DATE: July 11, 2012

TO: All Prospective Bidders

SUBJECT: Addendum No. 2
 US 50 HOV Lanes Phase 0 El Dorado Hills Interchange
 Project
 Contract No. PW 12-30639, CIP No. 53124

U-5

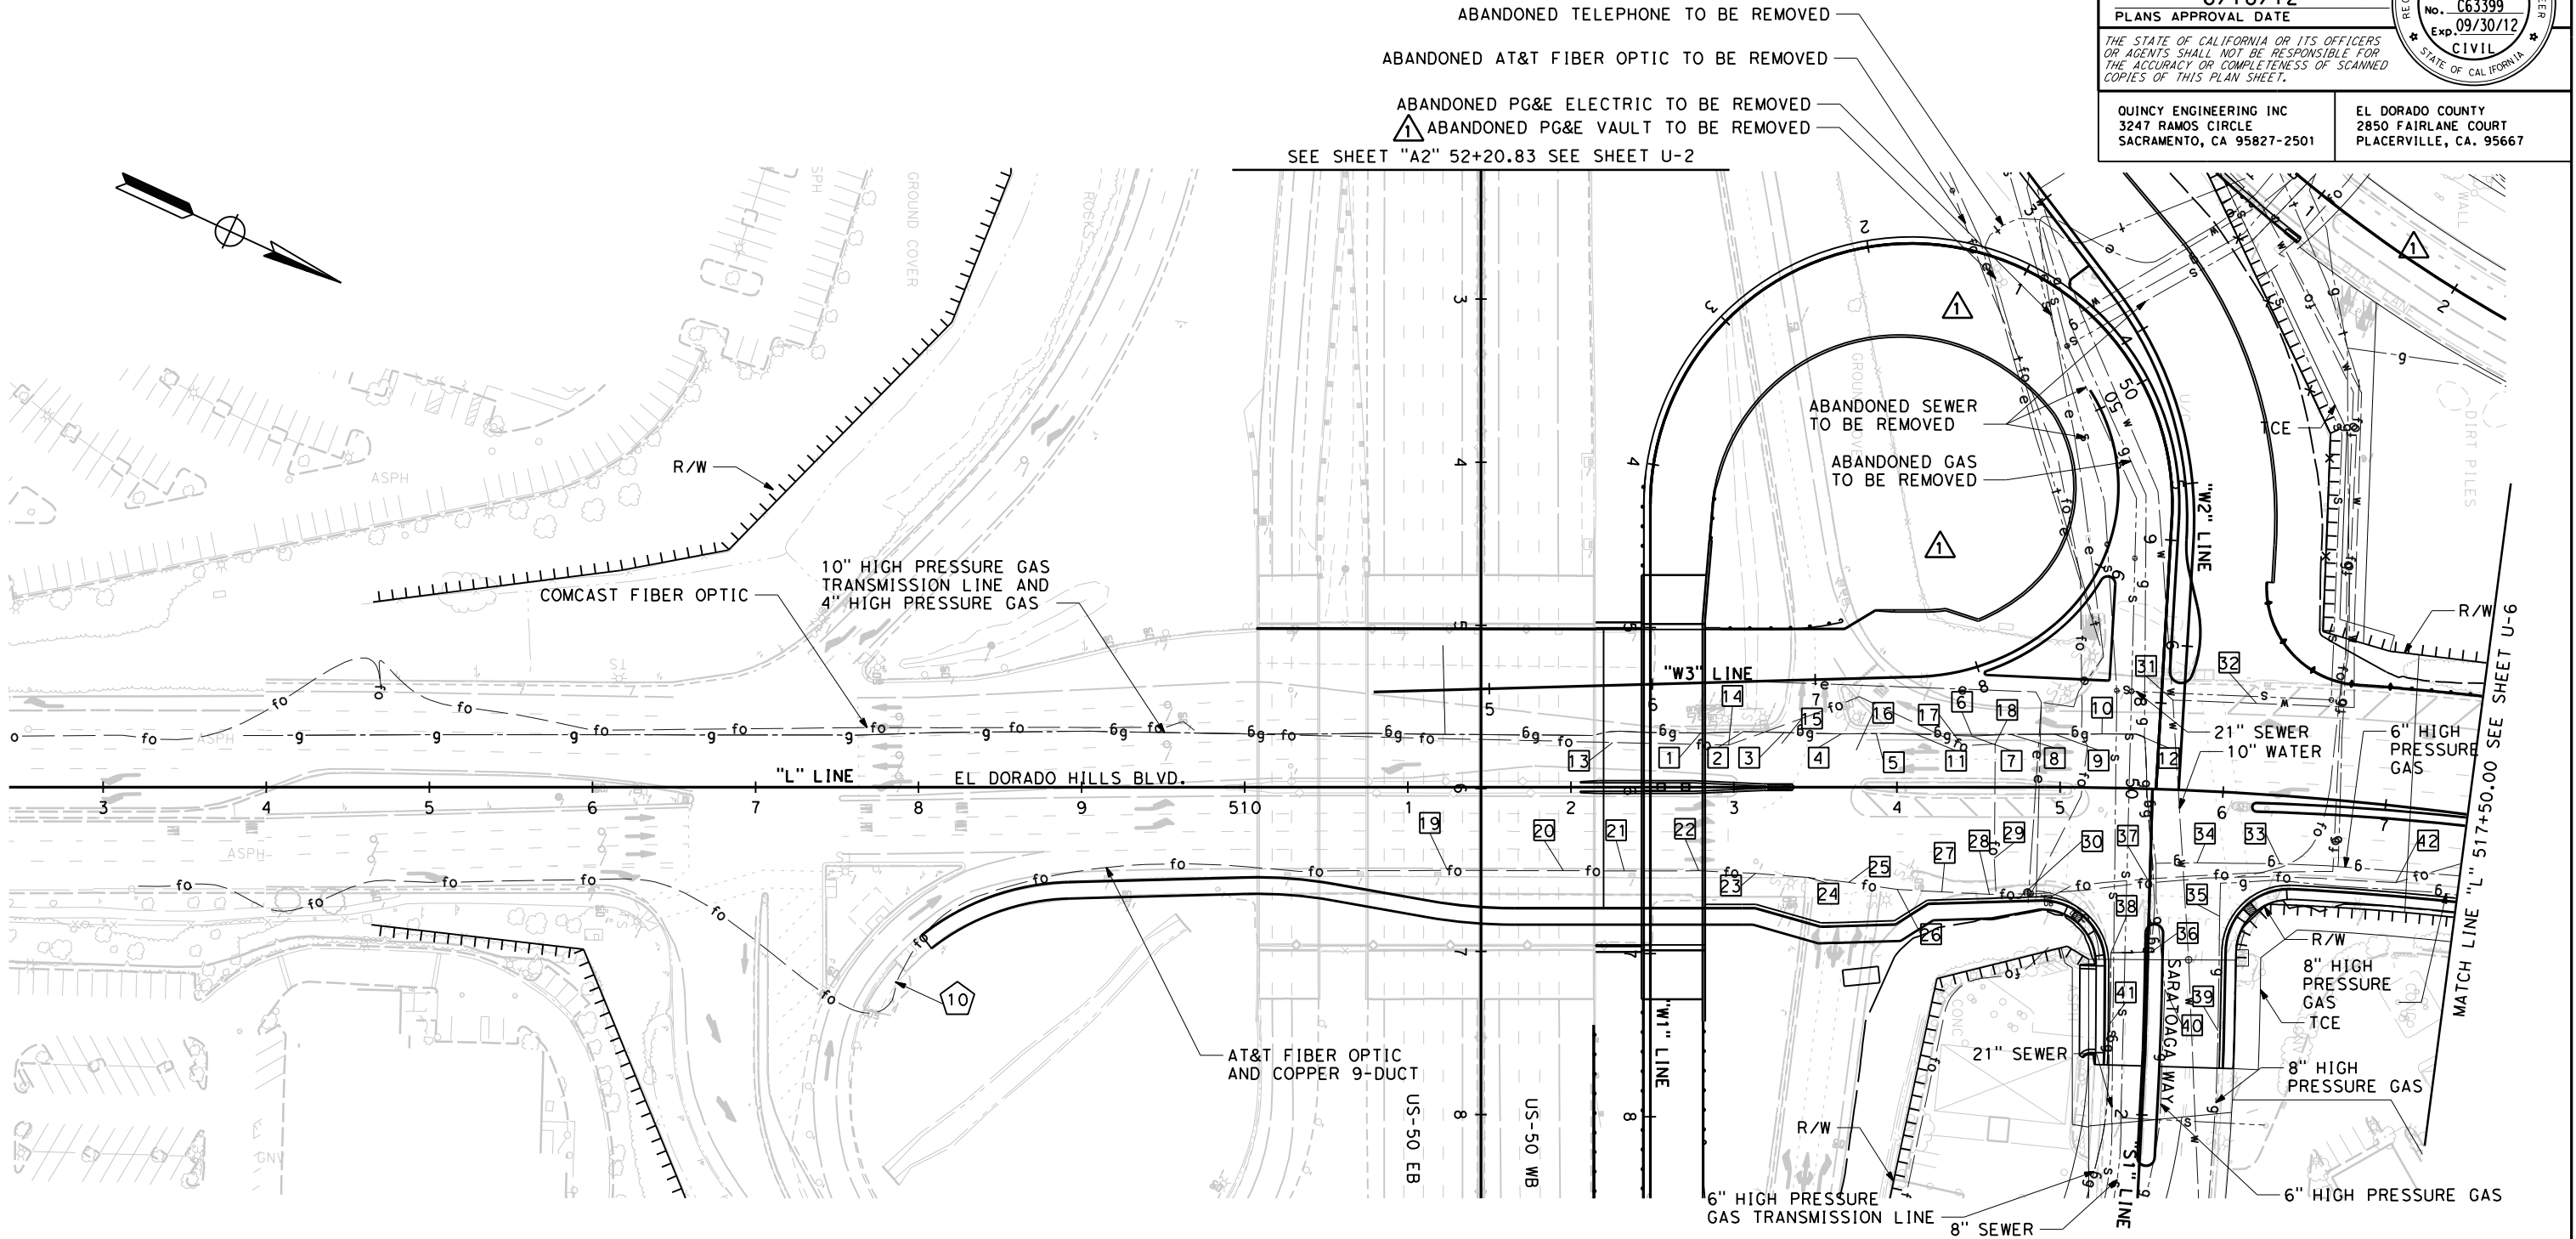
MARK	DATE	DESCRIPTIONS	BY	CH'D
△	7-12	UTILITY CALLOUT REVISIONS	VFD	CG3
REVISIONS

TH-11

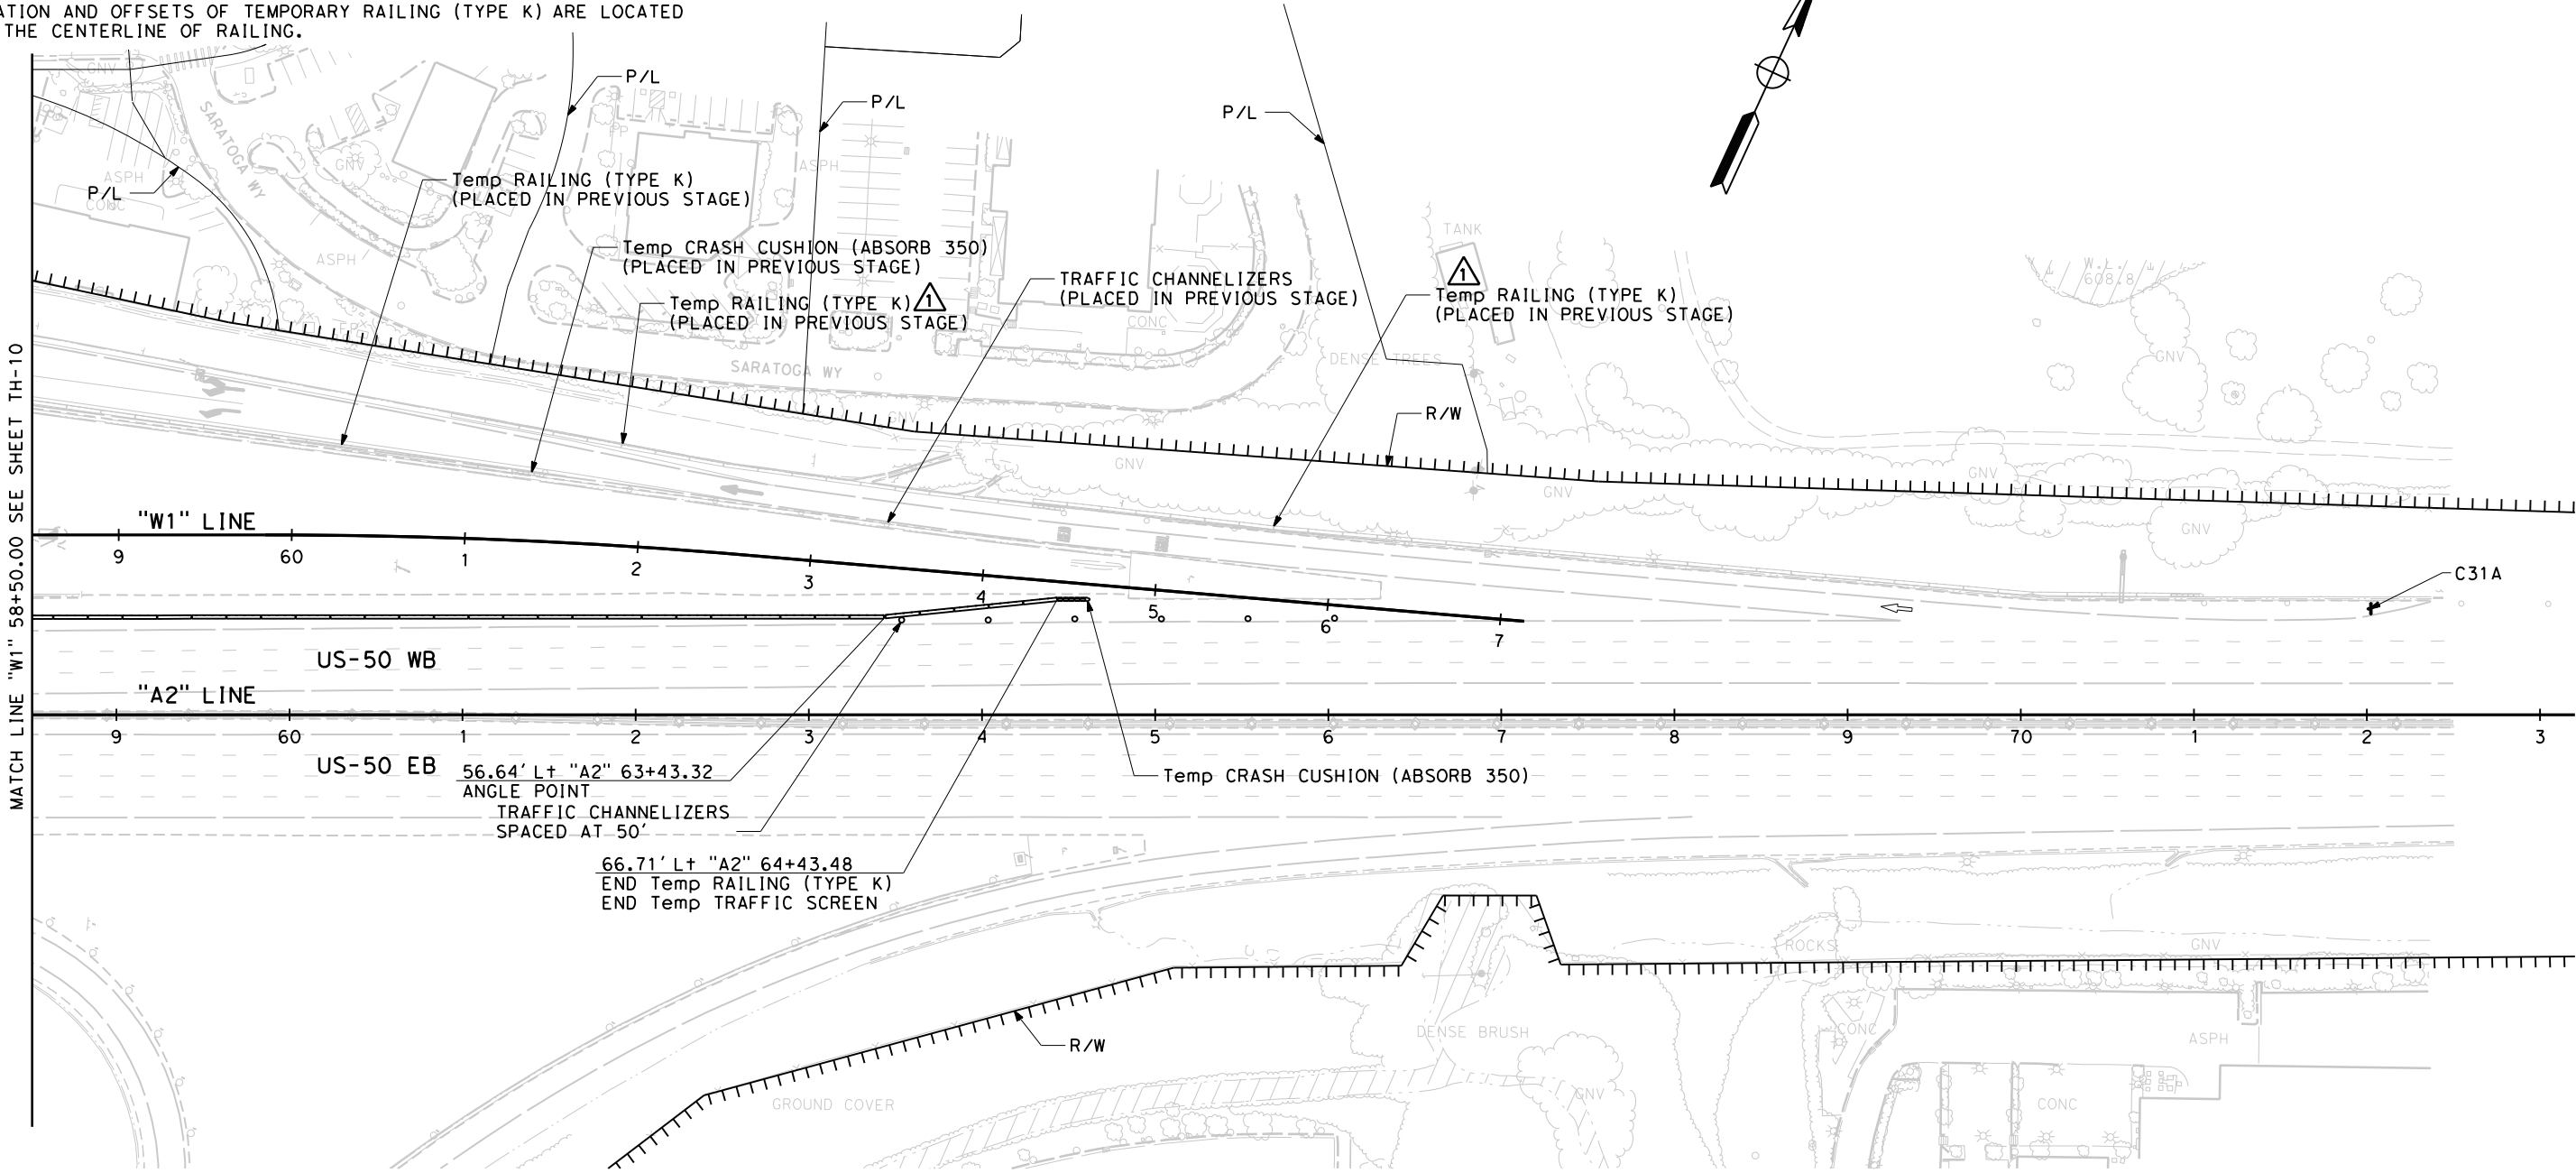
MARK	DATE	DESCRIPTIONS	BY	CH'D
1	7-12	TEMP RAILING CALLOUT REVISIONS	VFD	CG3
		REVISIONS

TH-16

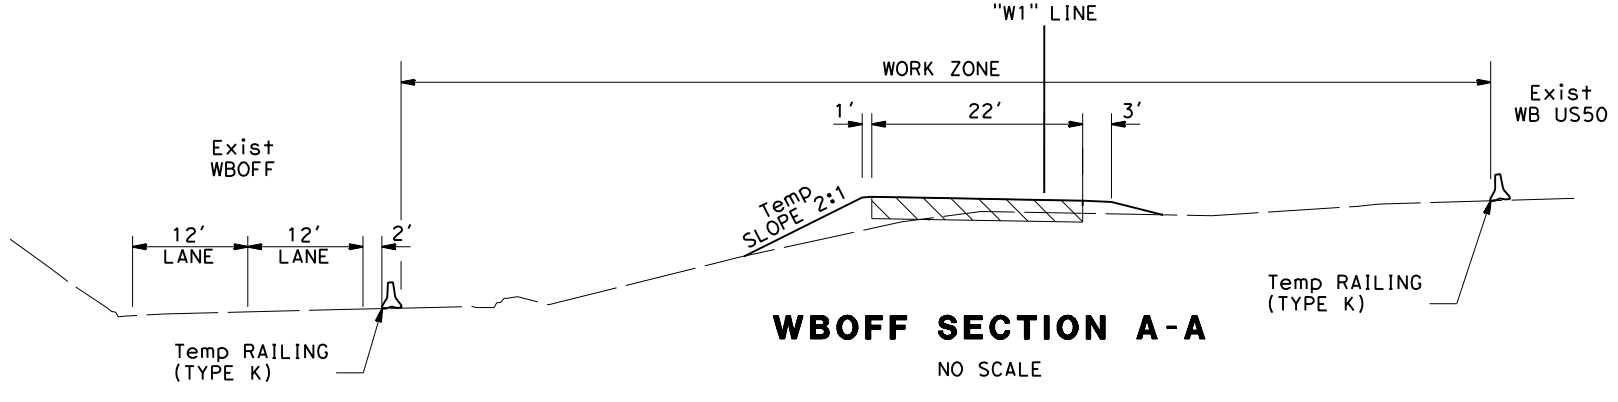
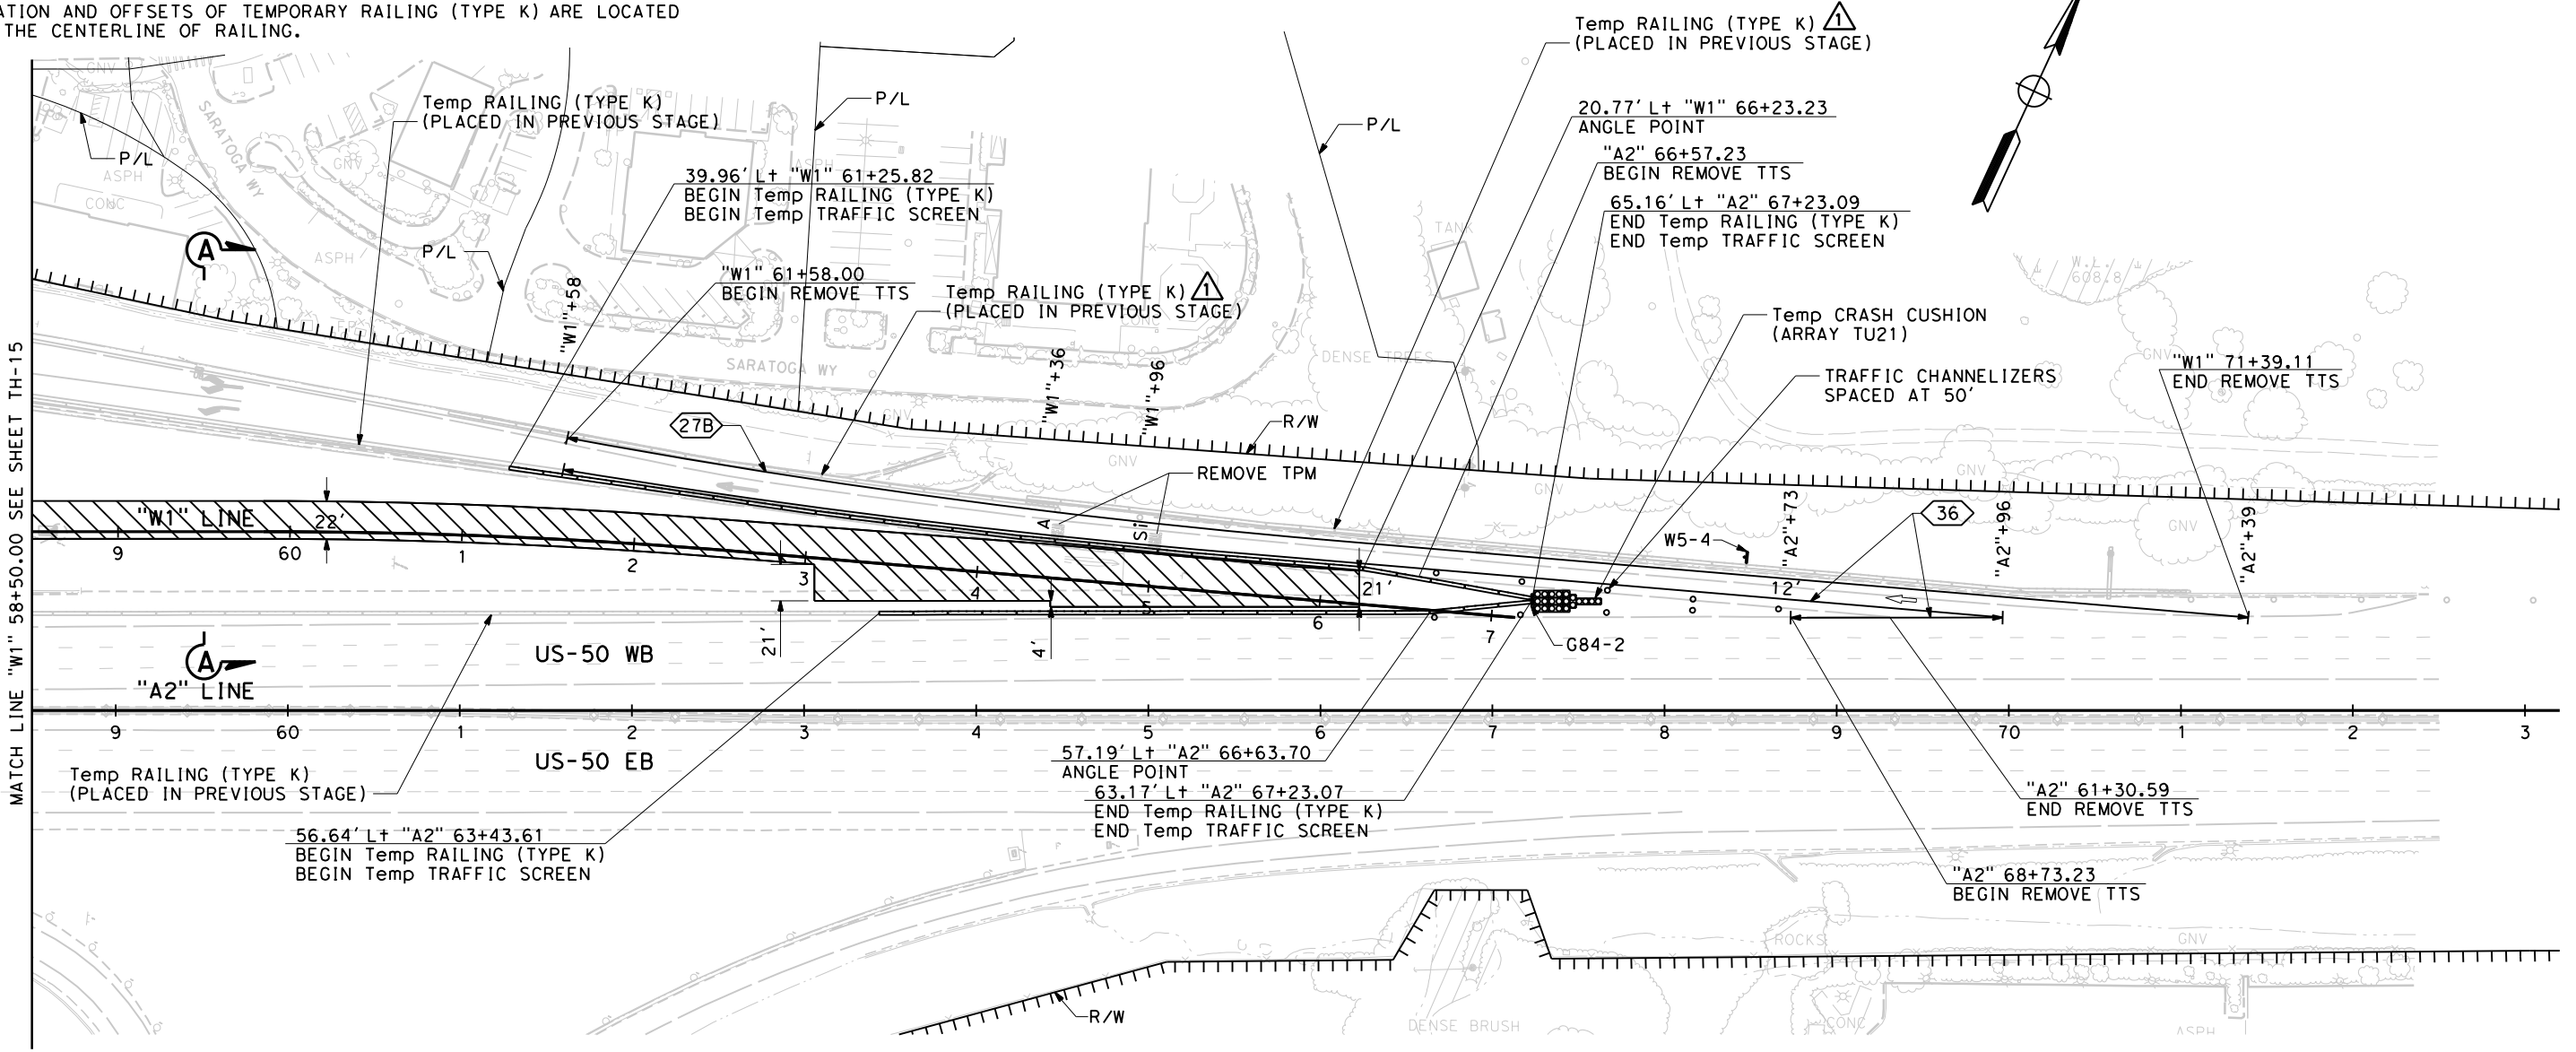
MARK	DATE	DESCRIPTIONS	BY	CH'D
1	7-12	TEMP RAILING CALLOUT REVISIONS	VFD	CG3
REVISIONS
